65-8

PAGE I OF II
NOVEMBER, 1965

TO: ALL ROOTES DEALERS
MODEL: ALL MODELS
SUBJECT: SELF CENTRALIZING SEALING WASHERS

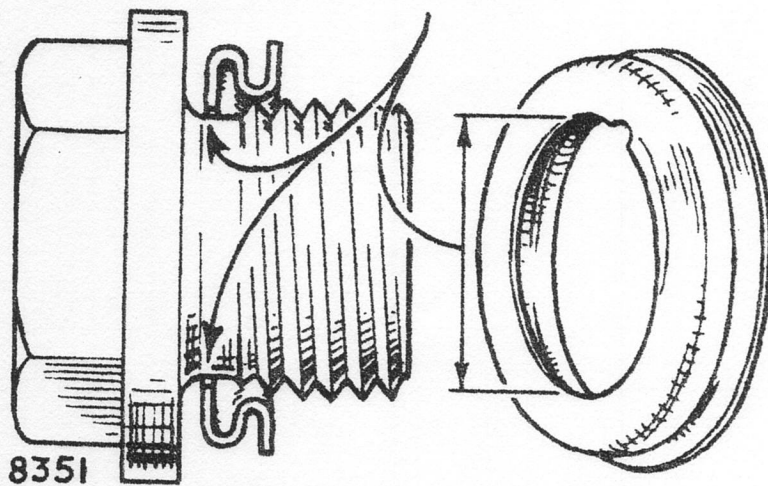
Various plugs on all models are now fitted with self-centralizing sealing washers, in particular the filler and drain plugs on gearbox, rear axle, etc.

Should it be necessary at any time to refit or replace these washers, it is important to ensure that the smaller internal diameter of the washer is placed towards the head of the plug as shown in the attached illustration.

These washers must not be forced over the plug threads but screwed on until the smaller diameter engages the waisted section between the threads and plug head.

Smaller Dia.
